Lots Road Power Station And Chelsea Creek

Planning Permission Ref. PP/02/01324 – Submission of Details Pursuant to Condition 6

Condition 6 – Vehicular Access

RBK&C TRANSPORTATION COMMENTS

Drawing Title
Proposed Layout
Lots Road Access
Sheet 1 of 2

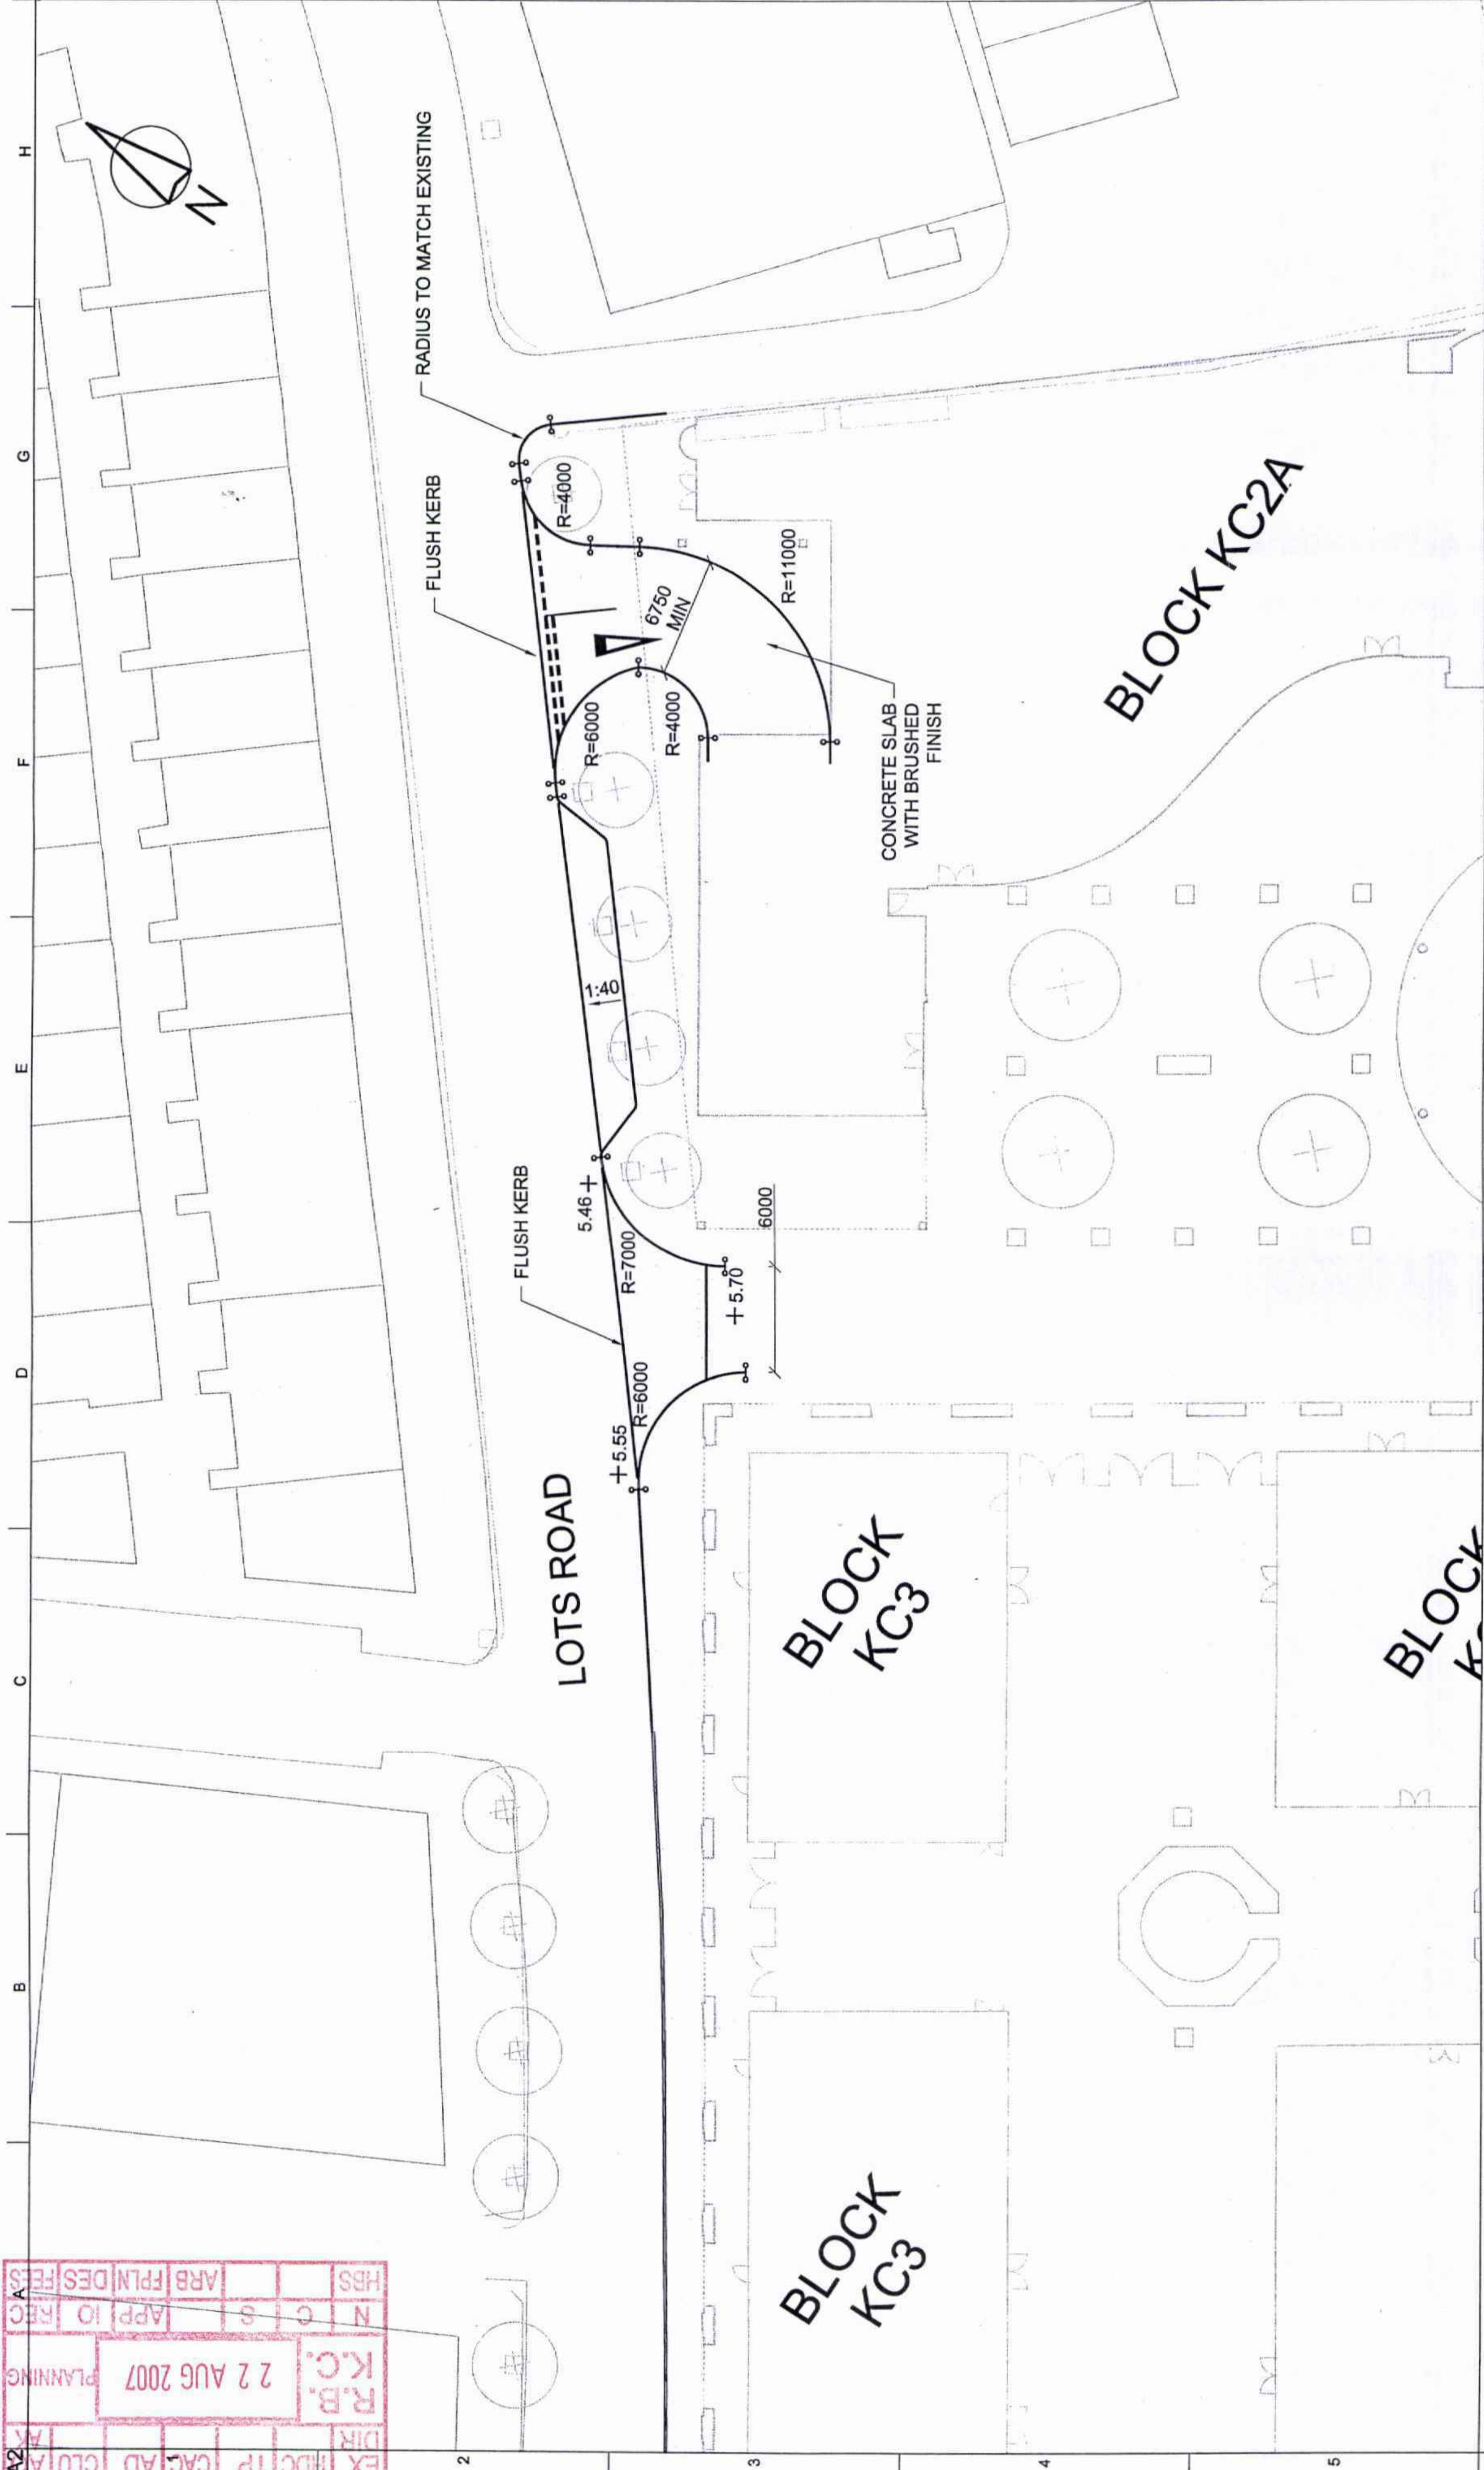
Drawing nos. 123162-03-38A, 41, 42 & 43 show the two accesses at the eastern end of the site with a lay-by for taxi rank/drop off. I assume the existing access will be closed? I assume this arrangement will require the kerb line to change and a motorcycle bay to be removed? The swept paths of 11m pantechicon turning right in or out suggest a loss of residents parking along north side of Lot Road, just east of Tadema Road. Is this correct? The taxi rank/drop off lay-by is sub-standard in width, only 1.4m wide. The swept paths of cars turning right in and out look as if they will require on street parking to be removed. Is this correct?

Drawing nos. 123162-03-38A, 41, 42 & 43 show the two accesses at the eastern end of the site with a lay-by for taxi rank/drop off. I assume the existing access will be closed? I assume this arrangement will require the kerb line to change and a motorcycle bay to be removed? The swept paths of 11m pantechnicon turning right in or out suggest a loss of residents parking along north side of Lot Road, just east of Tadema Road. Is this correct? The taxi rank/drop off lay-by is sub-standard in width, only 1.4m wide. The swept paths of cars turning right in and out look as if they will require on street parking to be removed. Is this correct?

prepared to suspend the development of the Taxi Rank and allow provision within the site boundary for taxis. Consequently, it is proposed to delete the Taxi Rank from all relevant drawings. See revised Arup drawing 123162-03-38B.

- 4) As previously confirmed, drawing 123162-03-38B enclosed shows that the taxi rank is deleted from the proposals. Please find enclosed copies of revised drawings 123162-03-41A, 42A and 43A. These drawings show that the suspension of resident parking bays are not required, even for occasional access for pantechon vehicles.
